# Access Compliance Report

## Public Rights-of-Way

### (Curb Ramps)

Intersection ID: 2910	Main Street: RIDGEFIELD_DR	Cross Street: SWANSTON_DR	Location: SE
ADA ID: 3D49E6D5BFD7	Ramp Type: PerpDiag	Initial Pass/Fail: Fail	Overall Compliance: No
		Severity Score: 42.5

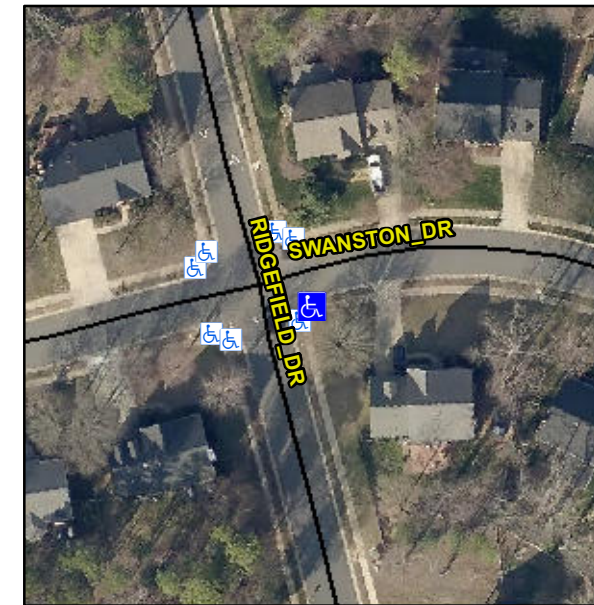
**Not Found, R304.5.1, R304.5.3**

Compliance	Description	Data	Compliance	Description	Data
N/A	Ramp Length (in)	46.0	Yes	Ramp Slope (%)	6.0
No	Ramp Width (in)	34.0	No	Ramp XSlope (%)	9.6
N/A	Flare Type LT	N/A	N/A	Flare Type RT	N/A
N/A	Flare Slope LT (%)	N/A	N/A	Flare Slope RT (%)	N/A
N/A	Flare Traversable LT?	N/A	N/A	Flare Traversable RT?	N/A
N/A	Landing Length (in)	N/A	N/A	DWS Provided?	N/A
N/A	Landing Width (in)	N/A	N/A	DWS Contrast?	N/A
N/A	Landing Slope (%)	N/A	N/A	DWS Length (in)	N/A
N/A	Landing X Slope (%)	N/A	N/A	DWS Full Width?	N/A
N/A	Landing Curb? (Y/N)	N/A	N/A	DWS Offset (in)	N/A
N/A	Shared Landing?	N/A			
N/A	Gutter Ponding?	N/A	N/A	Gutter Slope (%)	N/A
N/A	Gutter Lip Ht (in)	N/A	N/A	Gutter X Slope (%)	N/A
N/A	Painted X Walk1?	No	N/A	Painted X Walk2?	No
	X Walk 1 Direction	To N		X Walk 2 Direction	To W
N/A	X Walk 1 Width (in)	N/A	N/A	X Walk 2 Width (in)	N/A
	X Walk 1 Slope (%)	1.8		X Walk 2 Slope (%)	4.9
	X Walk 1 X Slope (%)	5.6		X Walk 2 X Slope (%)	0.3

N/A	Ramp inside XWalk1?	N/A	N/A	Ramp inside XWalk2?	N/A
	Road Slope (%)	6.3	N/A	Clear Space?	N/A
	Road X Slope (%)	4.9	N/A	Clear Space to XWalk (in)	N/A
N/A	Any Obstructions?	N/A	N/A	Storm Grate/Utility Hazard?	N/A
	Obstruction Type			Storm Grate/Utility Type	
		N/A			N/A
			Yes	Surface Condition? (G/P)	Good

**Remove & Replace Curb Ramp With Two New Directional Ramps or Equivalent.**
